CO14 – Clean Air Council

**Re: Transcontinental Gas Pipe Line Company, LLC;
Draft Environmental Impact Statement for the Planned Atlantic Sunrise Project,
Docket No. CP15-138-000**

Intervenor Clean Air Council ("Council") hereby submits the following comments on the Draft Environmental Impact Statement ("Draft EIS") prepared by the Federal Energy Regulatory Commission ("FERC" or the "Commission") with respect to Transcontinental Gas Pipe Line Company, LLC's ("Williams" or "Transco") proposed Atlantic Sunrise pipeline project (the "Project"). These comments are timely submitted.

Figure 1: Unconventional shale gas wells drilled in Pennsylvania (2004 – June 30, 2015).

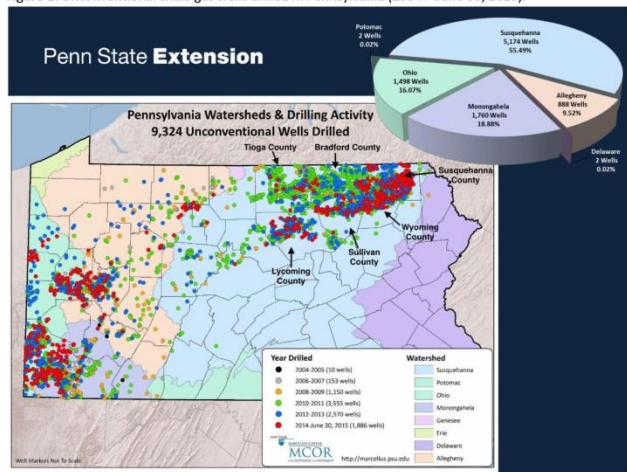
These are important considerations as DEP reviews Transco’s application for the Atlantic Sunrise Project. The entire Pennsylvania component of the Atlantic Sunrise Project is located within the Susquehanna River watershed. See FERC DEIS at 4-48, Table 4.3.2-1. In addition, at least 55% of the over 9,300 shale gas wells that have been drilled in Pennsylvania, have been drilled in the Susquehanna River watershed. See Figure 1 below.

the most forested part of the Susquehanna River watershed. As Figure 1 above shows, most of the shale gas development that has occurred in the Susquehanna River watershed has been concentrated in six counties in northeastern Pennsylvania. While some of this development has certainly impacted forests, much of the existing shale gas development has occurred areas dominated by agriculture. Compare Figure 1 with Susquehanna River Basin Commission, Susquehanna River Basin – Land Use Land Cover, 2006, available at http://srbc.net/atlas/downloads/BasinwideAtlas/PDF/1507_LandUse.PDF.

Section 4.5.5 of the EIS assesses the extent and impact of tree clearing within the region of influence (or geographic scope) for the Project. An assessment of the broader impacts of shale gas development, including the associated clearing of trees, is beyond the scope of this project review. See the response to comment PM1-6.
